## Staff Report

Date: June 26, 2020  
To: Chief Administrative Officer  
From: James van Hemert, Consulting Planner  
Re: **Application for a Development Permit for Rem. Lot A, Plan VIP64669, District Lot 13, Cowichan Lake Land District**

### APPLICATION

The applicant requests a ***Development Permit*** to allow for a subdivision comprising 47 residential lots and a strata lot on 6.85 ha.

Figure 2 Riparian Assessment Area & SPEA

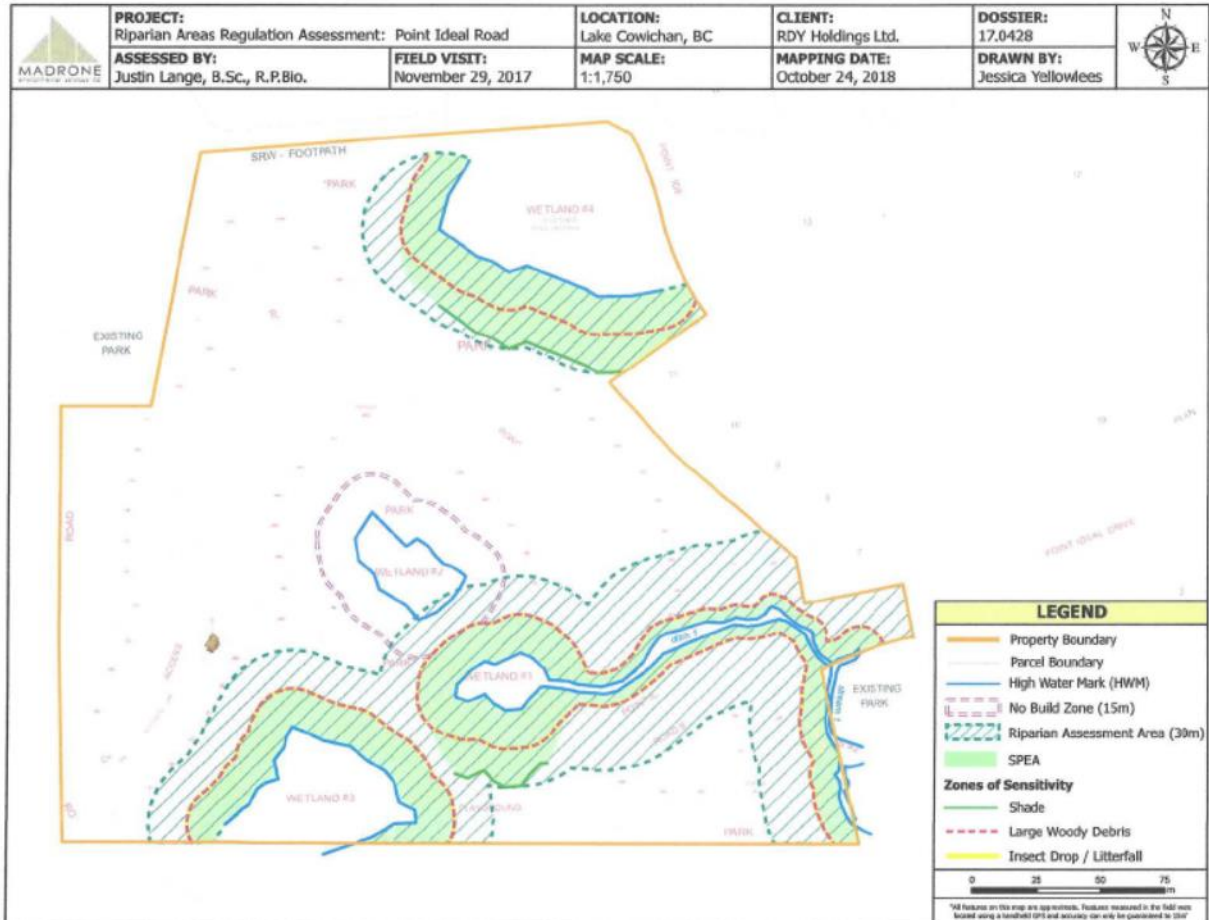
The current subdivision plan introduces an incursion into the SPEA with a collector status roadway between Wetland #1 and Wetland #3. The civil engineer for the project, Jon Irving, notes the following:

*The preparation of a revised RAR report is not necessary at this time – approval of plans and crossings can be addressed with the Town and through Section 11 Notifications*

- *Point Ideal Drive has been designed and is to be constructed over the footprint of a previously constructed road which fell in SPEA boundaries, which is noted in the RAR report – the QEP has been made aware of this throughout the design process and has no objection to this methodology.*
